PROJECT: Charleston & Westwind Retail Center

CITY OF LAS VEGAS INTER-OFFICE MEMORANDUM		DATE: February 8, 2021
TO: Land Development Services Department of Building & Safety		FROM: Albert Sung, P.E. Flood Control Project Engineer Department of Public Works
SUBJECT:	Drainage Study for:	COPIES TO:
Charleston & Westwind Retail Center		McCay Engineering
Cross Streets:	SEC Charleston Blvd. & Westwind Road	LDR Partners
File Number:	F:\Depot\DSMemos\DS5399B.doc	Bart Anderson, P.E., DevCo
Parcel Number:	163-01-510-001 & 163-01-510-004	CCRFCD
Zoning Action:	20-0023-VAR1; SDR-78460; VAR-78455; VAR-78456 & ZON-78454	
FEMA Flood Zone	YES	NO X
Proposed Storm Drain	YES	NO X

ADDENDUM #1 TO THE TECHNICAL DRAINAGE STUDY FOR CHARLESTON & WESTWIND RETAIL CENTER

Subject: **ADDENDUM #1 TO TECHNICAL DRAINAGE STUDY FOR CHARLESTON & WESTWIND
RETAIL CENTER**

DR1

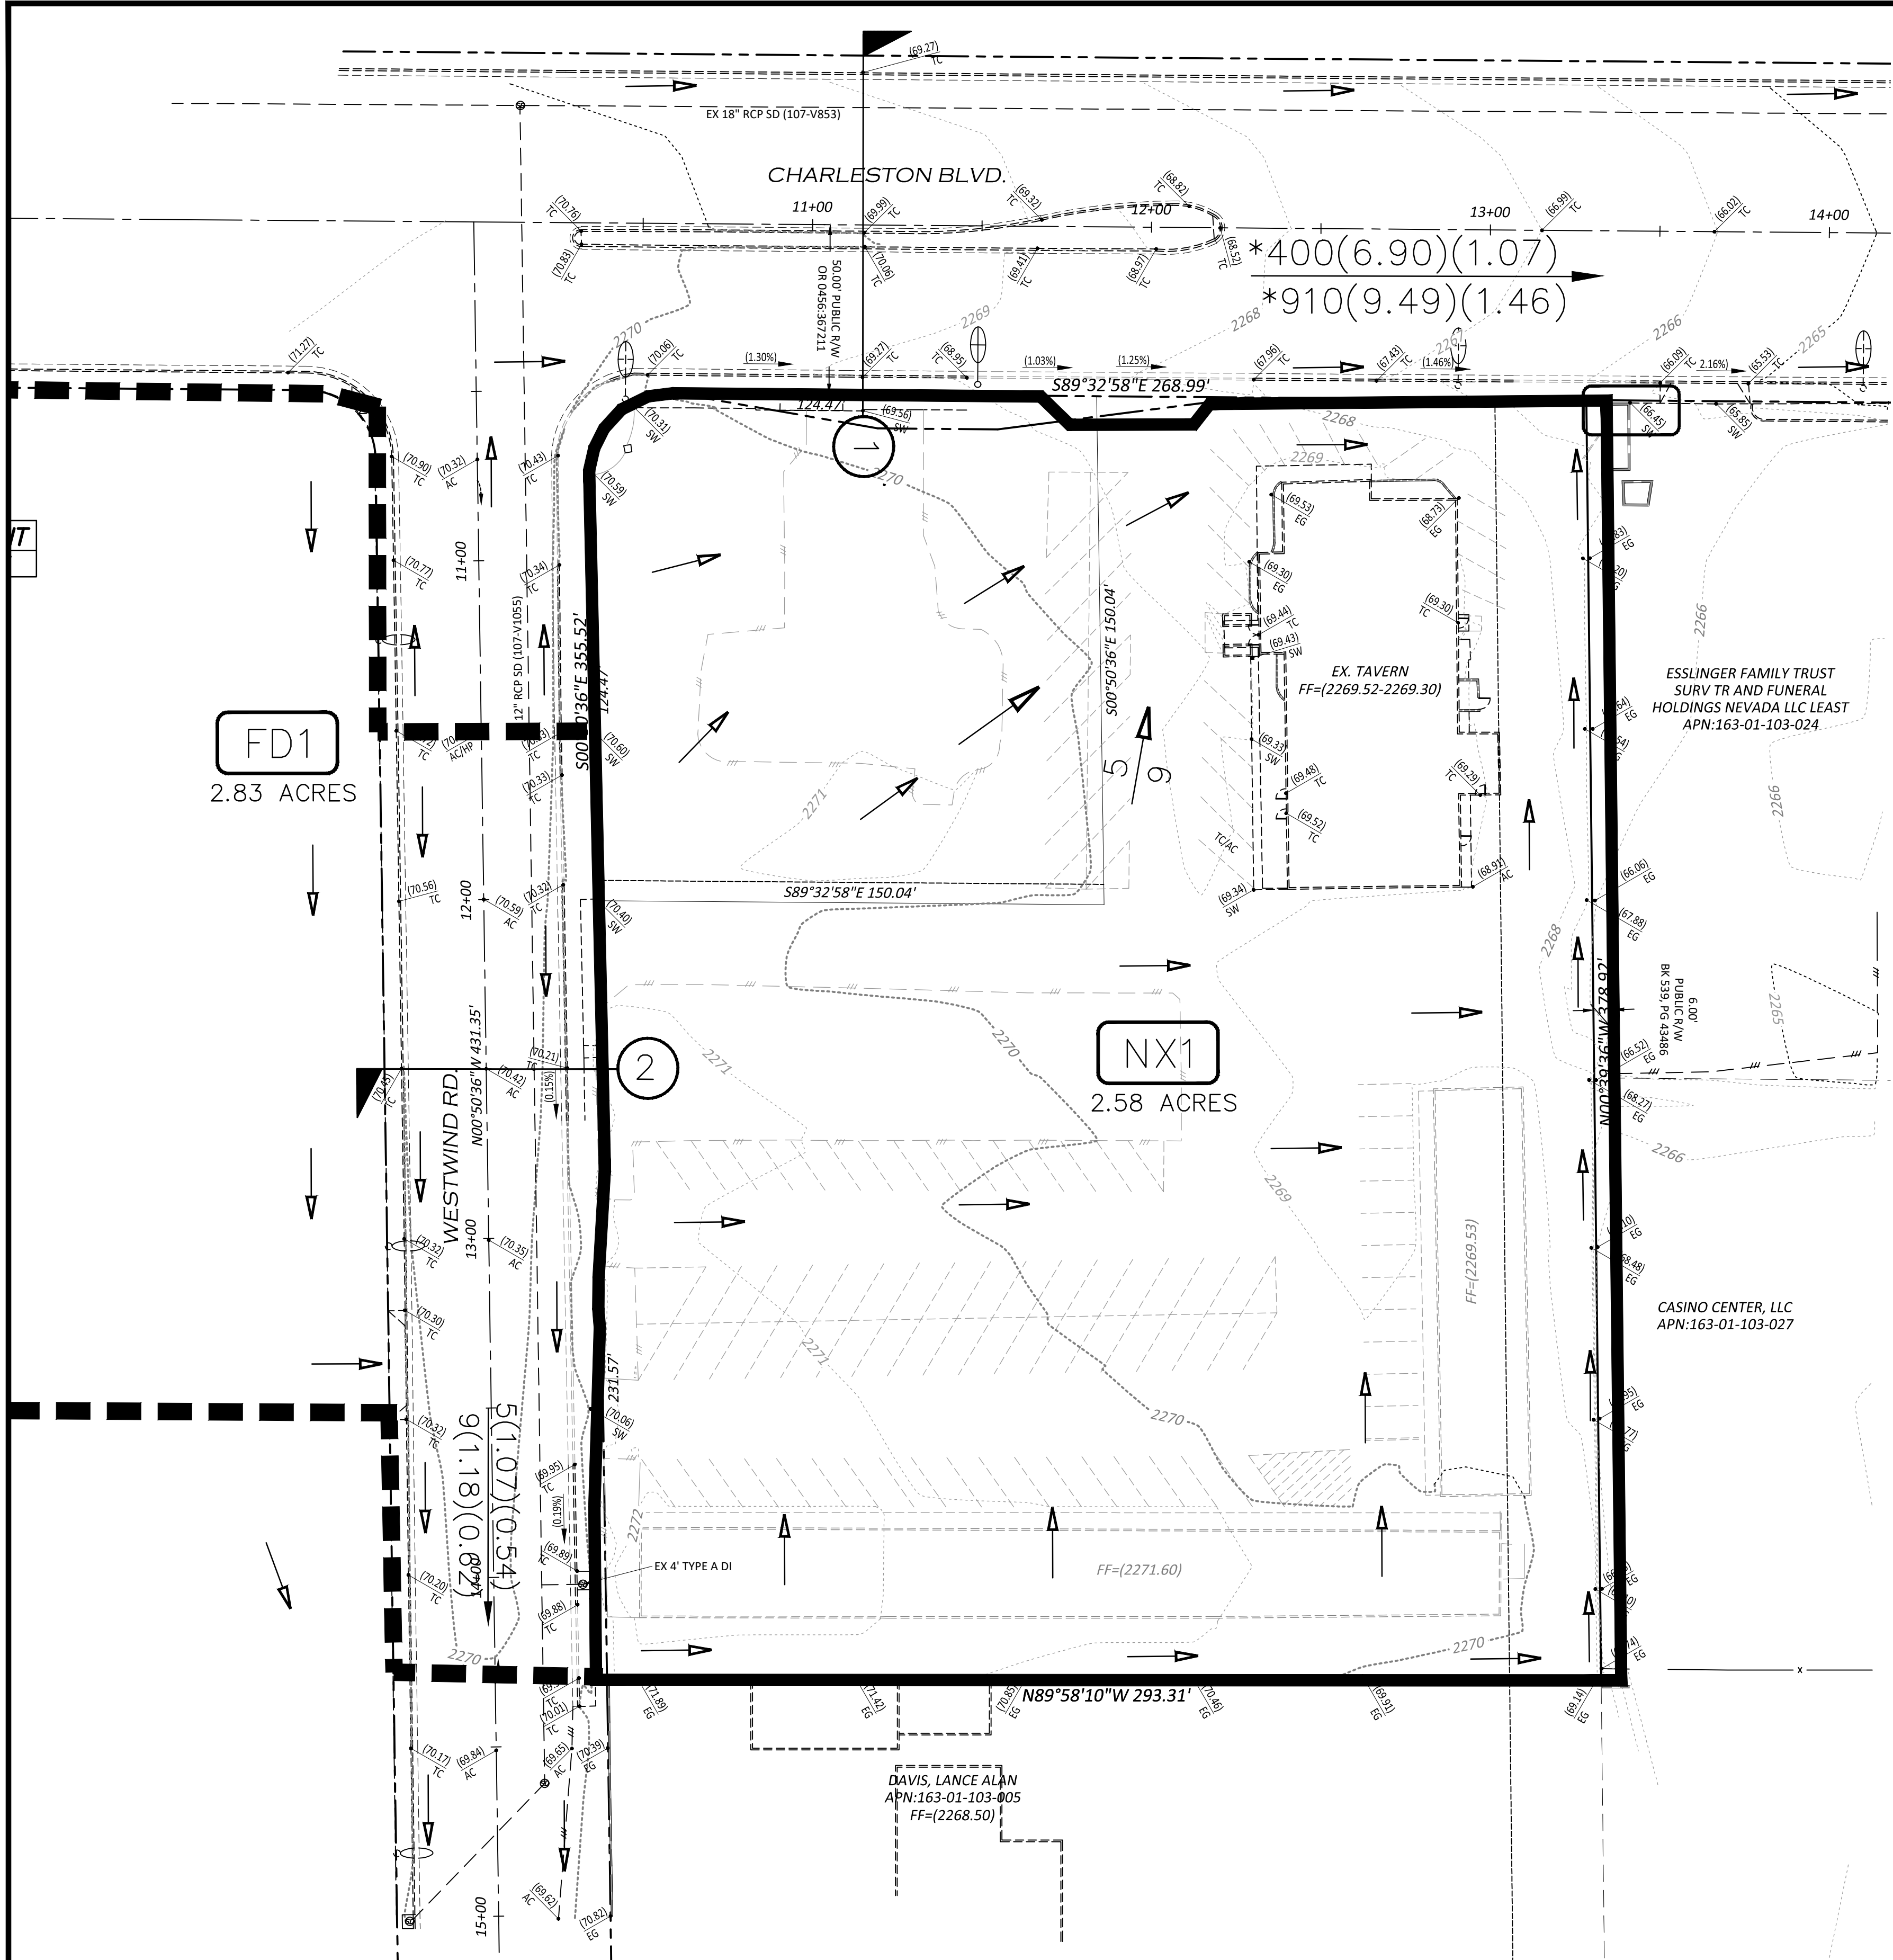
Comment 4: Provide street names on the grading plan and all drainage basin plans.

Response 4: Noted. Street names have been provided on the Grading plan and Drainage Plans. See revised Plans with this submittal.

DR2

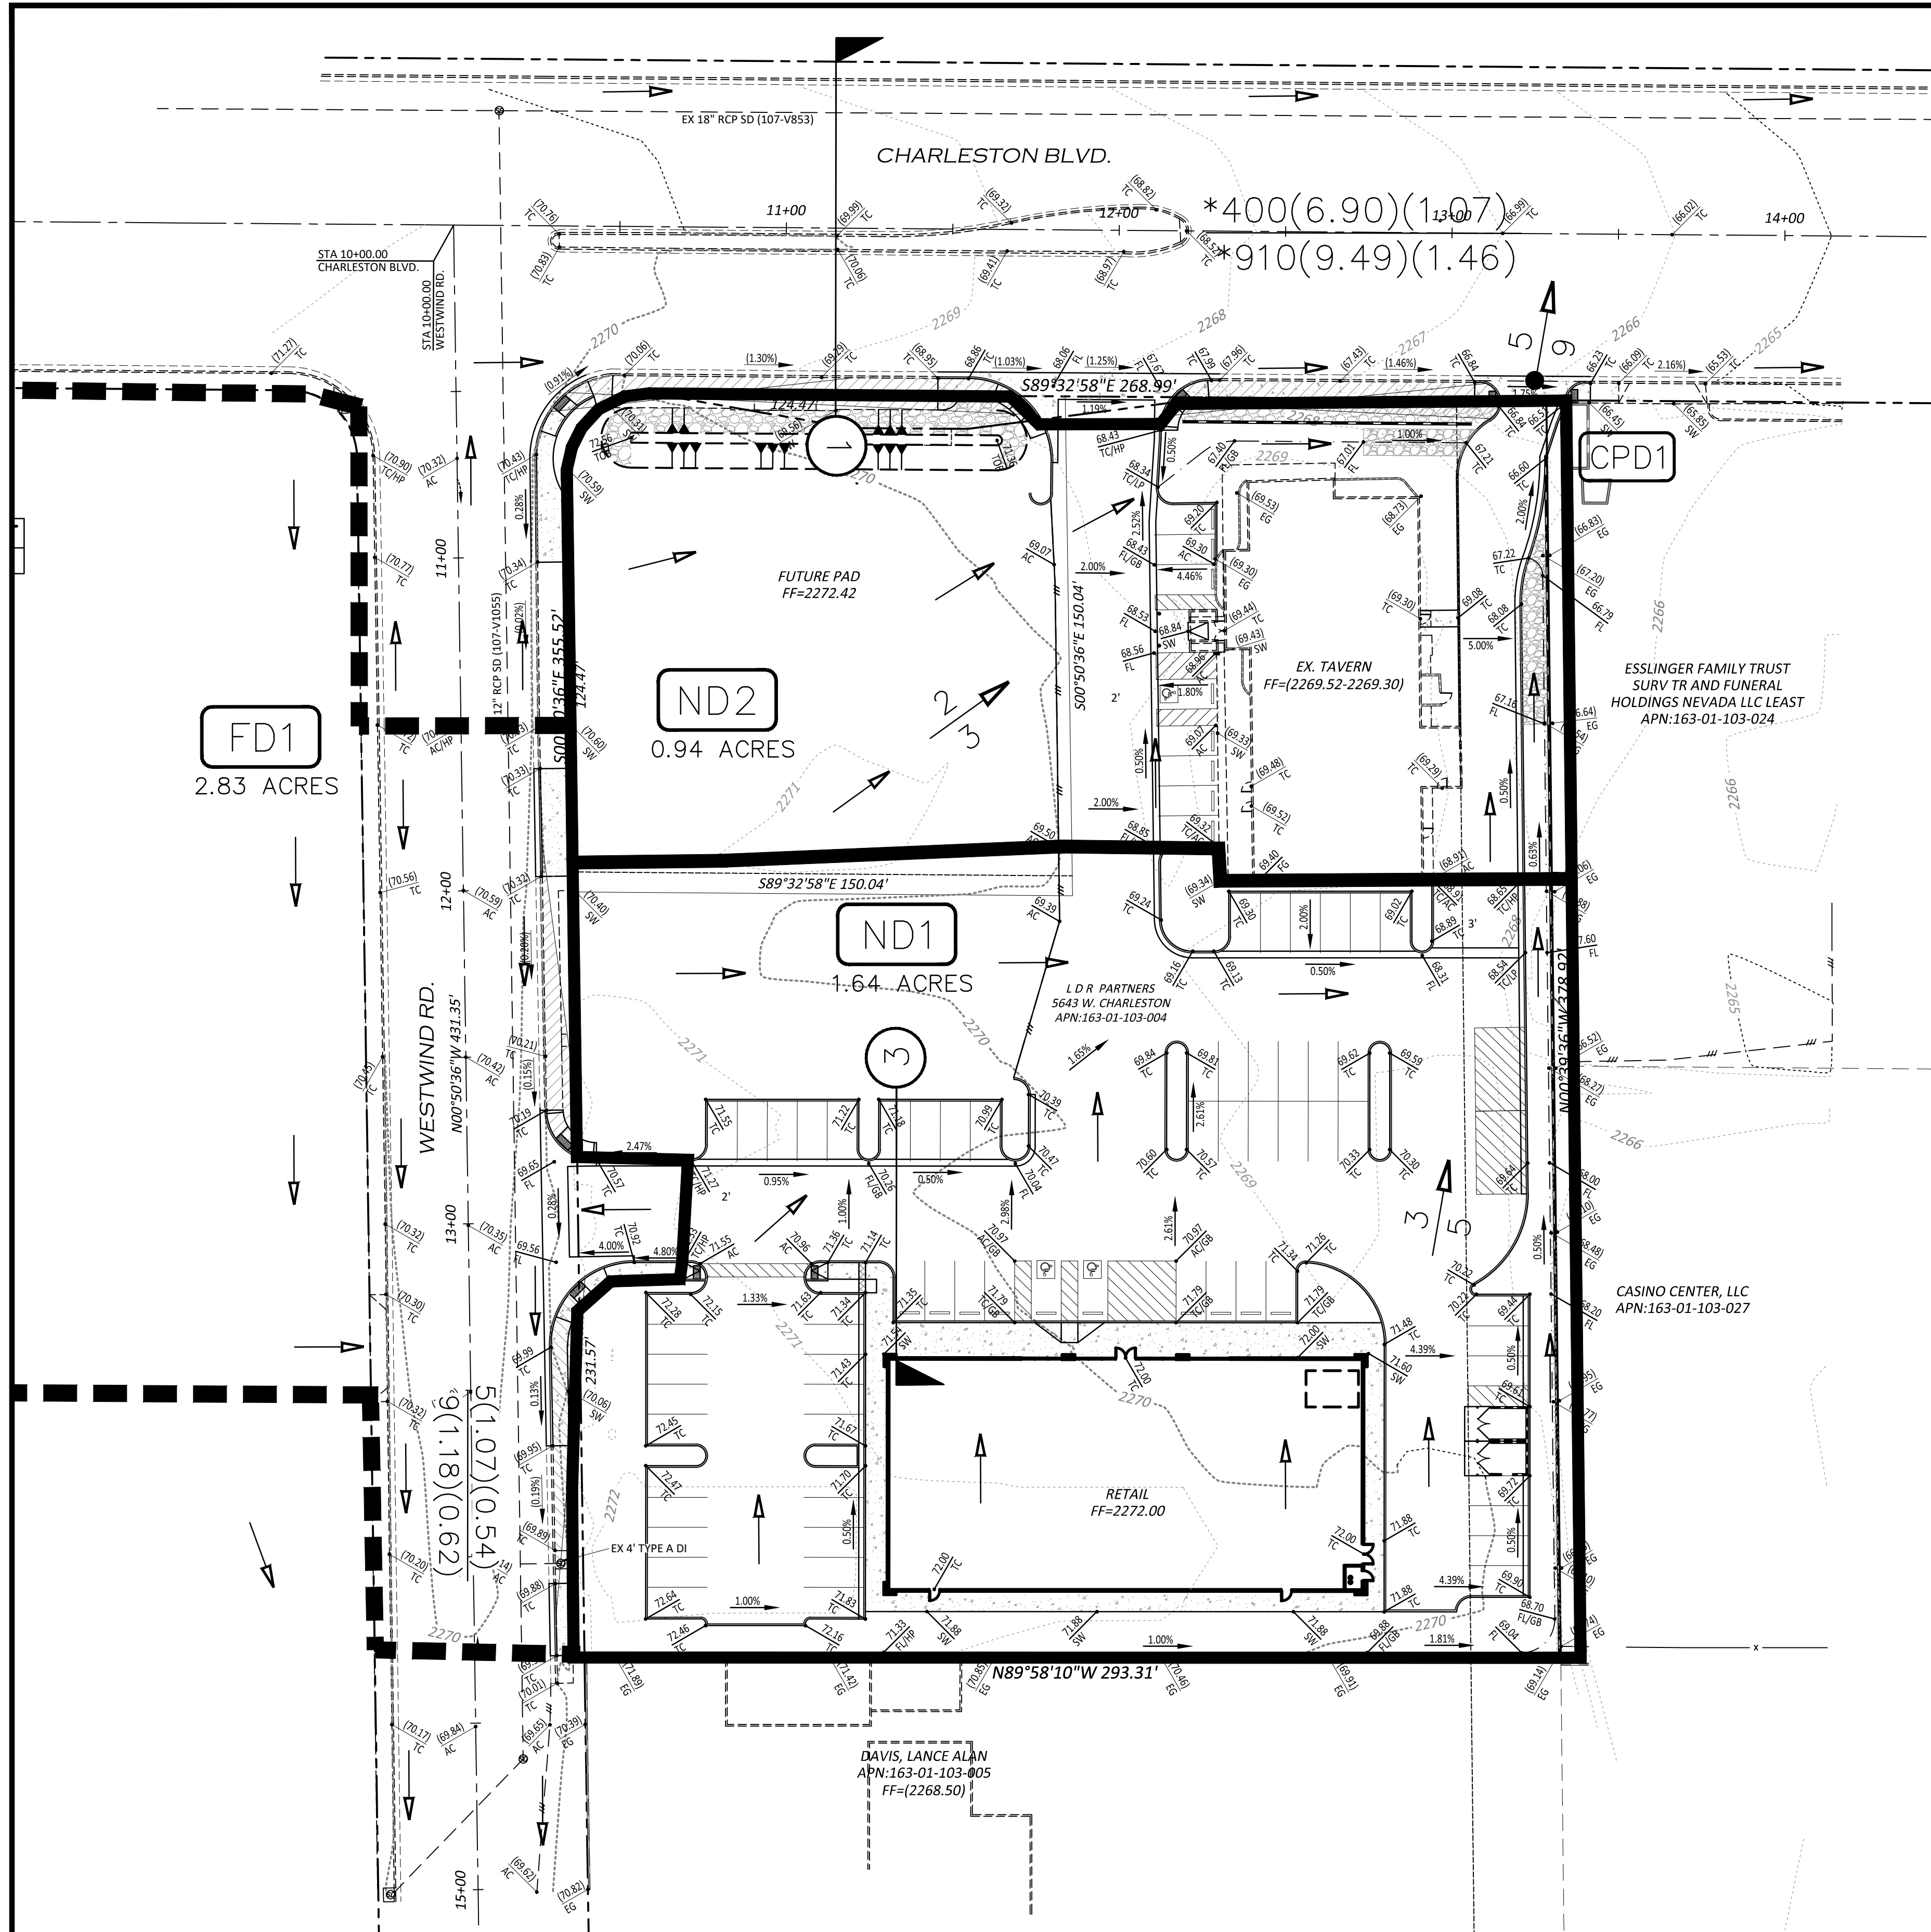
Comment 7: Provide erosion protection measures behind the sidewalk in *Cross Section A*.

Response 7: We have provided a hydraulic section for Charleston Blvd. using the 1.46% slope at Section 'A'. Utilizing the 100yr velocity, we have provided a riprap calculation that shows approximately 13-inch riprap is needed for erosion control behind the sidewalk. See revised plans and calculations within the submittal.
